Re: Mail Control No. 594447

### Decommissioning Survey

NRC License # 24-35155-01

**From:** Tran, Frank [mailto:Frank.Tran@nrc.gov]  
**Sent:** Friday, May 05, 2017 2:35 PM  
**To:** Greg Sackett  
**Subject:** Request additional information for NRC License No. 24-35155-01 (Integrated Science Support, Inc.)

See Attached Drawing for Location of Wipes and Surveys

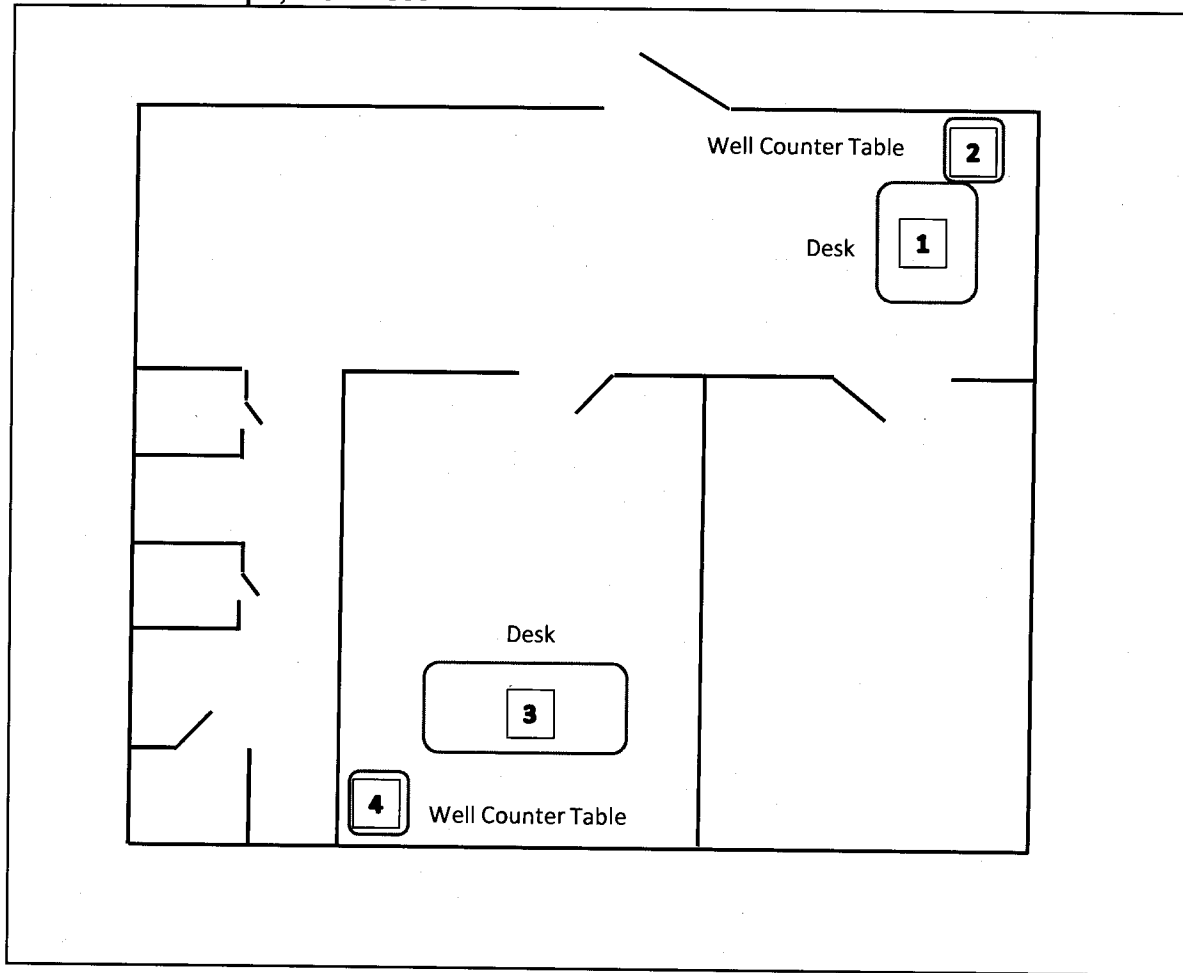
We have reviewed your request dated April 5, 2017. We determined that the record was incomplete. Specifically, the decommissioning survey stated that a drawing for the location of wipes and surveys was attached; however, we could not locate the drawing. Please provide a copy of the drawing for the location of wipes and surveys which was discussed in the decommissioning survey. Please indicate Mail Control No. 594447 in your response to facilitate proper mail handling in our office.

In response to the request for additional information, please see attached decommissioning report which includes the survey map.

The drawing should have been part of the file that was original sent. My apologies if this was not the case. See attached.
